Re: **Agency Response**
 Shell-branded Service Station
 6039 College Avenue
 Oakland, California
 Incident # 98995745
 Project # 245-0503

On behalf of Equilon Enterprises LLC dba Shell Oil Products US, Cambria Environmental Technology, Inc. (Cambria) is submitting this correspondence to address the technical comments listed in the Alameda County Health Care Services Agency (ACHCSA) letter dated March 21, 2003.

**Proposed Soil Boring
 Location Map**

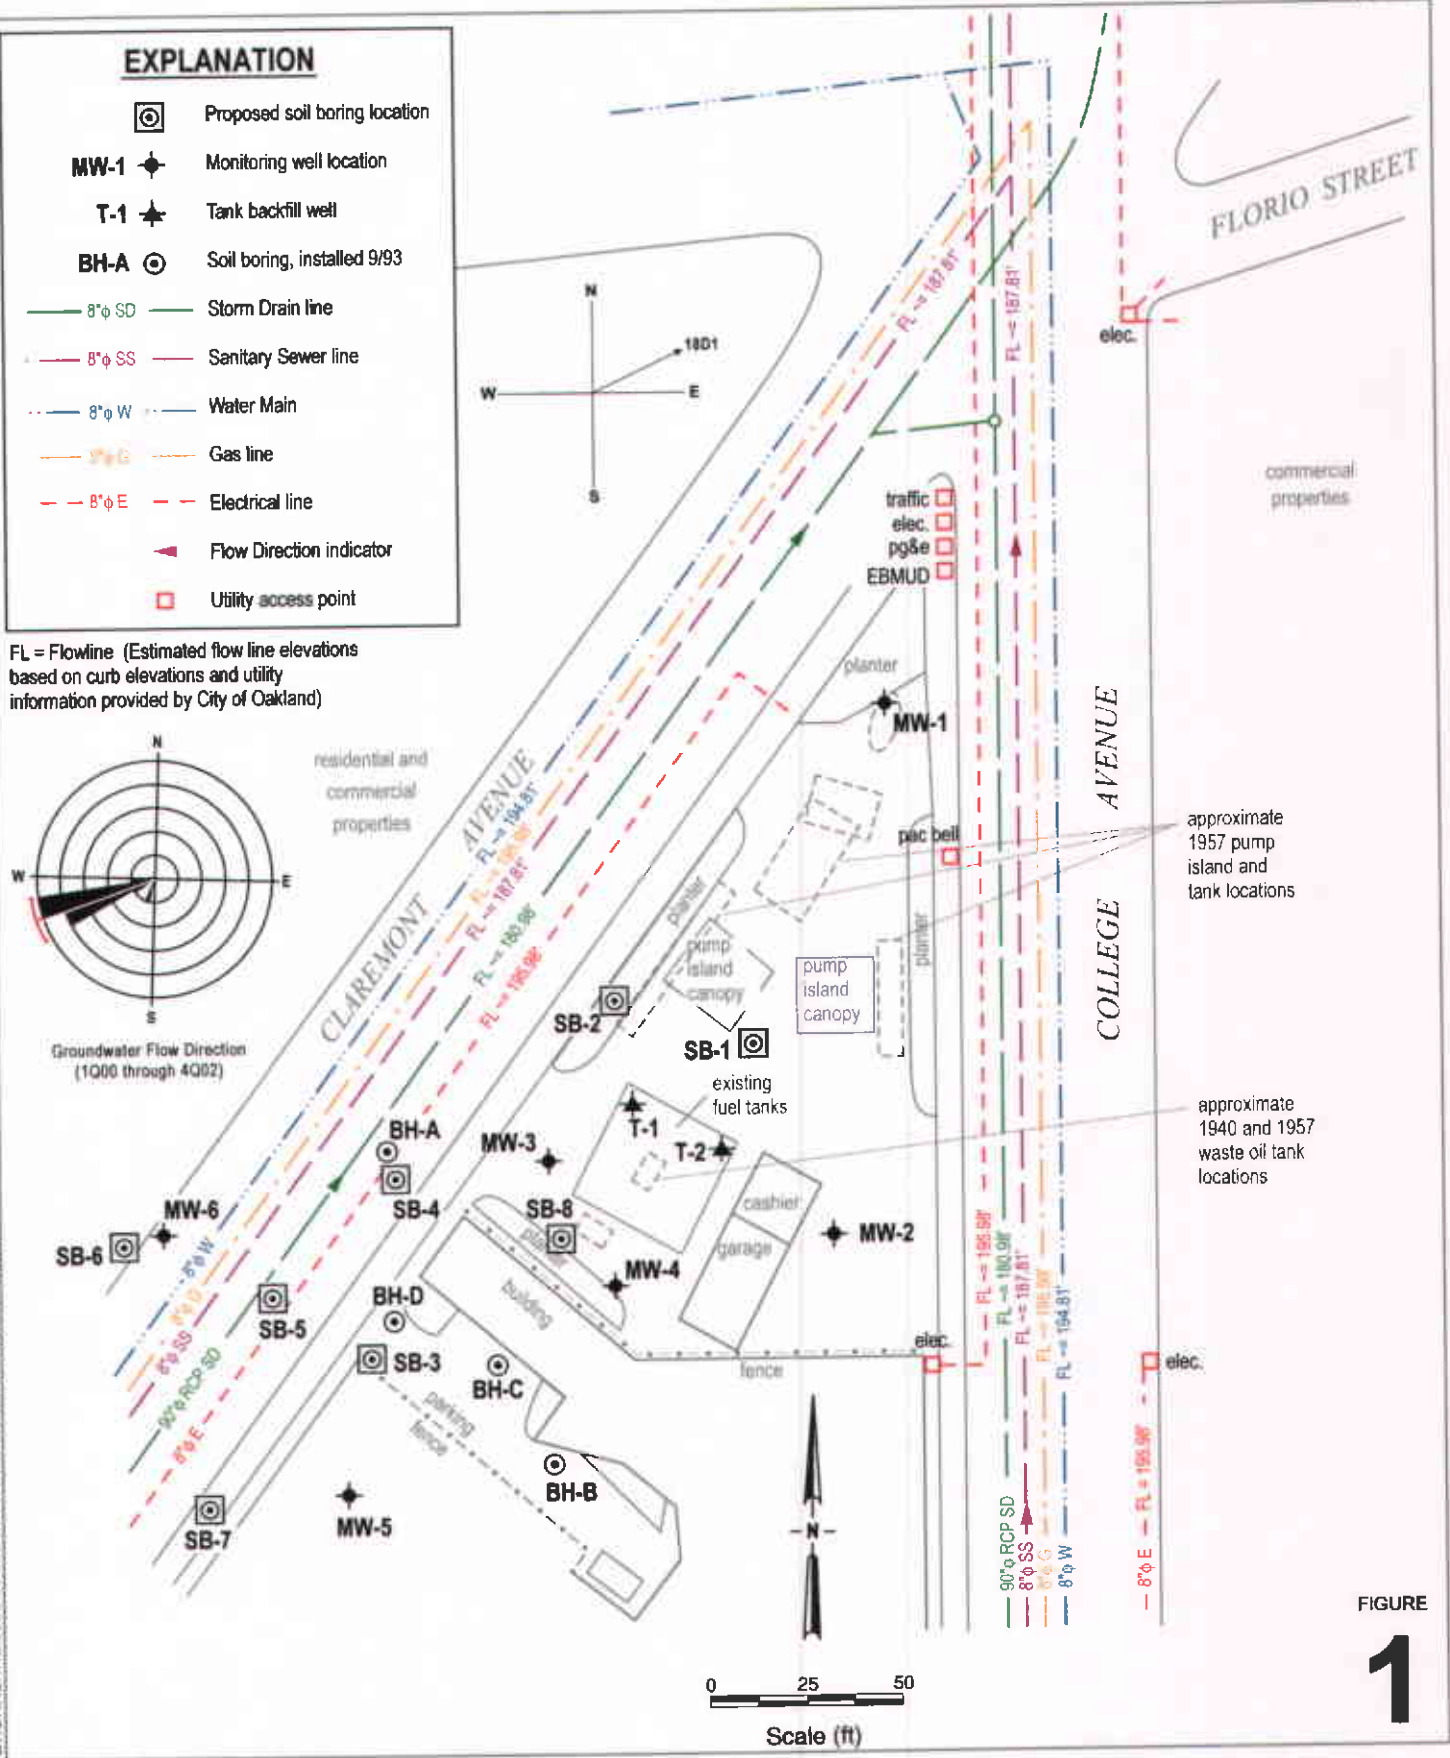
As stated in Cambria’s January 6, 2003 *Subsurface Investigation Work Plan*, the objective of the proposed investigation is to define the extent of MTBE in groundwater southwest of the site and to determine whether offsite utility trenches provide preferential pathways for chemical migration. ACHCSA has noted that two onsite and three offsite soil borings (SB-1 through SB-5, Figure 1) proposed in Cambria’s January 6, 2003 work plan were inadequate to define the vertical and lateral extent of the plume at the site. ACHCSA has also requested that Cambria submit geological cross-sections to explain the rationale for the proposed soil boring locations.

2. Source Characterization – ACHCSA has requested that Cambria propose additional borings to characterize the suspected source area. As noted above, Cambria will advance a total of nine borings, including one boring immediately downgradient of the pump islands (SB-1) and one boring immediately downgradient of the tank complex (SB-8). Cambria will log the borings for lithologic description and submit selected samples for chemical analysis based on changes in lithology and areas of obvious contamination as well as depth of the soil/groundwater interface. Based on the proposed investigation results, Cambria will determine whether further investigation is required in order to adequately characterize the suspected source area.

Claremont Avenue clearly exists. Cambria is proposing to install three soil borings in and near the utility trenches (SB-4, SB-5 and SB-9) to determine whether chemicals from either on- or offsite sources may have impacted the utility trenches. Cambria will prepare cross-sectional drawings showing utilities, site stratigraphy, updated top-of-casing elevations, depth to water and chemical concentrations from soil boring data from the proposed investigation.

Concurrent with this letter, Cambria is submitting *Subsurface Investigation Work Plan Amendment* that provides for additional offsite soil borings and for collecting depth-discrete grab-groundwater samples at selected locations. To provide more adequate plume definition downgradient of the site, Cambria has added three offsite soil borings (SB-6, SB-7 and SB-9) and one onsite boring (SB-8) to the investigation scope of work. During the investigation, all soil borings (SB-1 through SB-9) will be logged continuously for lithologic description. Cambria will collect one grab-groundwater sample from each boring and select soil samples for chemical analysis based on changes in lithology, areas of obvious contamination and the depth of the soil/groundwater interface. Additional borings will be advanced adjacent to SB-2, SB-3, SB-7 and SB-8 to collect depth-discrete groundwater samples for investigating the vertical distribution of hydrocarbon and MTBE in groundwater. The depth and number of depth-discrete samples will be determined by the observed lithology. Based on investigation results, Cambria will assess whether further investigation or monitoring well installation is necessary to define the plume.

Figure 2

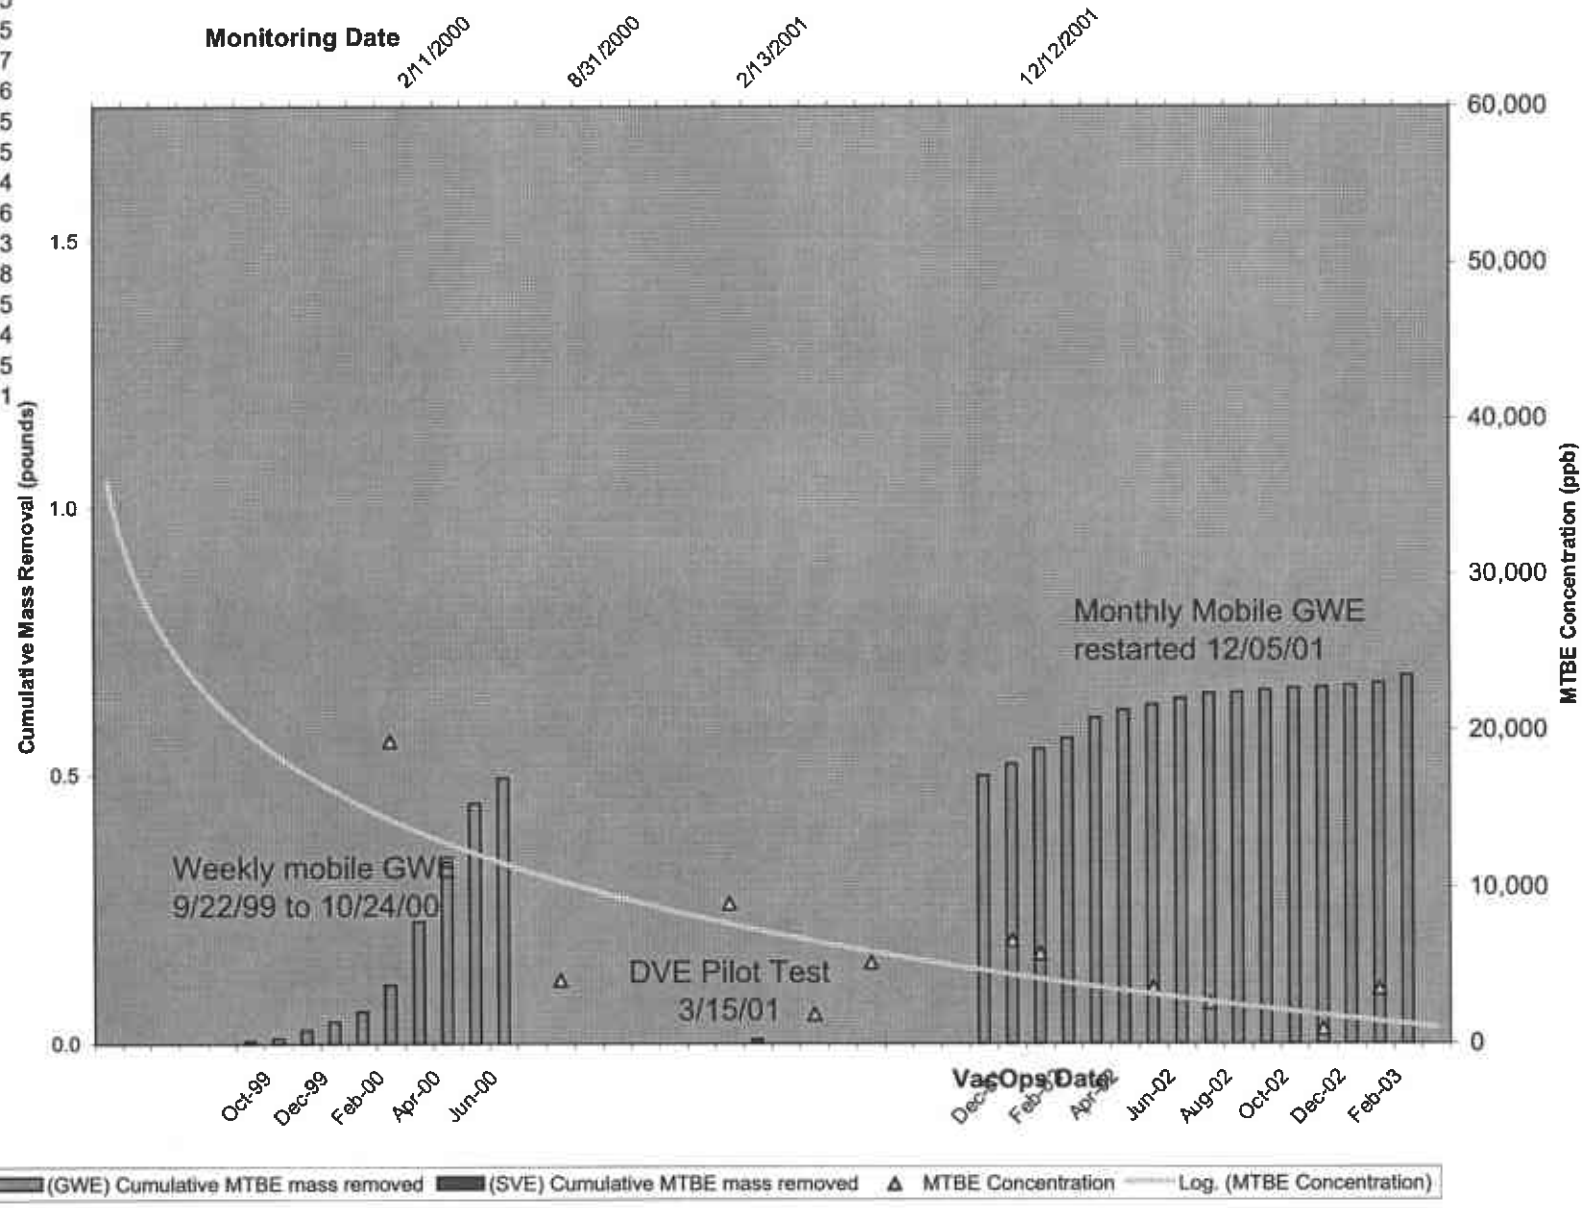
4. Migration Control/Source Remediation – ACHCSA indicated that they believe that the total fluid extraction by vacuum truck operations (VacOps) does not appear to have resulted in a significant reduction in contaminant concentrations. Graphical evaluation of VacOps effectiveness (Figures 2 and 3) has been included with quarterly monitoring reports since the fourth quarter of 2001. When VacOps began in September 1999, MTBE concentrations in MW-3 were 19,300 parts per billion (ppb), analyzed using EPA method 8020. Using EPA method 8260 for analysis, MTBE concentrations in MW-3 have decreased from a high of 6,600 ppb in December 2001 to a low of 940 ppb in November 2002. Similarly, MTBE concentrations in MW-4 have decreased from 30,300 ppb in February 2000 to 770 ppb in November 2002. Cambria believes that these concentration reductions are significant. When MTBE concentrations in the target wells decreased to below 1,000 ppb in the fourth quarter of 2002, Cambria discontinued VacOps. However, MTBE concentrations in target wells MW-3 and MW-4 increased to 3,500 ppb and 8,900 ppb, respectively, in the first quarter of 2003 and VacOps was reinstated in April 2003.
